Indicates changes to approved planning application 2019/6088/P and approved LBC 2019/6270/L

Project
65 Kingsway - Base Scheme

Title
Typical Core Details

Drawing No.
1914-BG-01-ZZ-DR-A-20.301

Typical Primary Core
1:30@A1, 1:60@A3

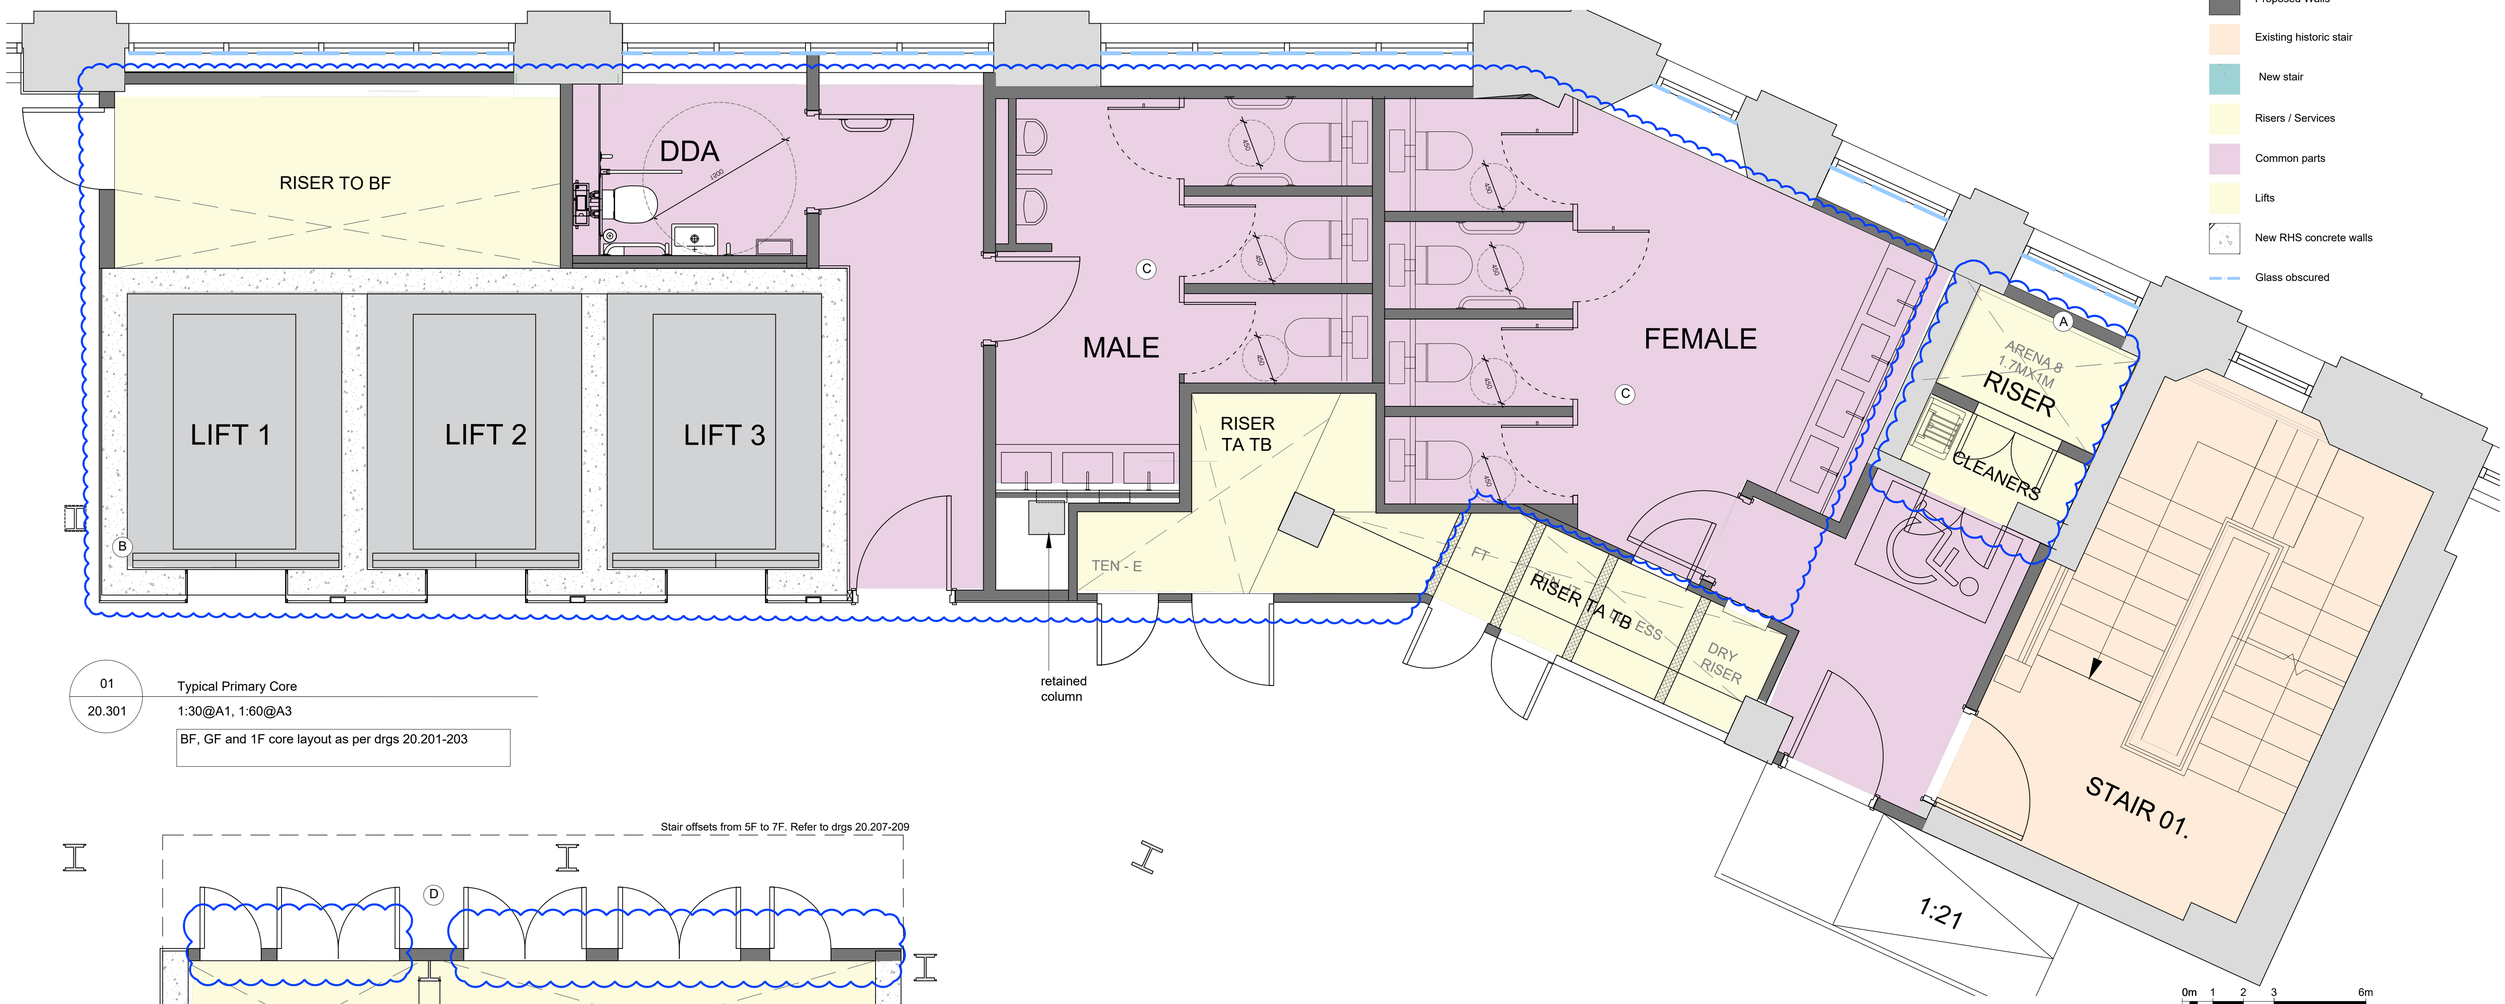
A. F/F Lift omitted and replaced as below
   - 1F to Roof: Riser and cleaners cupboard
   - BF - GF: Goods lift. Ref to drg 20.201 and 20.202

B. Lift bank shifts approx 300mm to GL/5 to accommodate existing structure.

C. WC layout amended to suit reconfigured goods lift/riser, retained column and lift bank position.

D. Riser wall shifts out by approx. 160mm. Note - No impact on historic fabric, or extent of slab demolition.
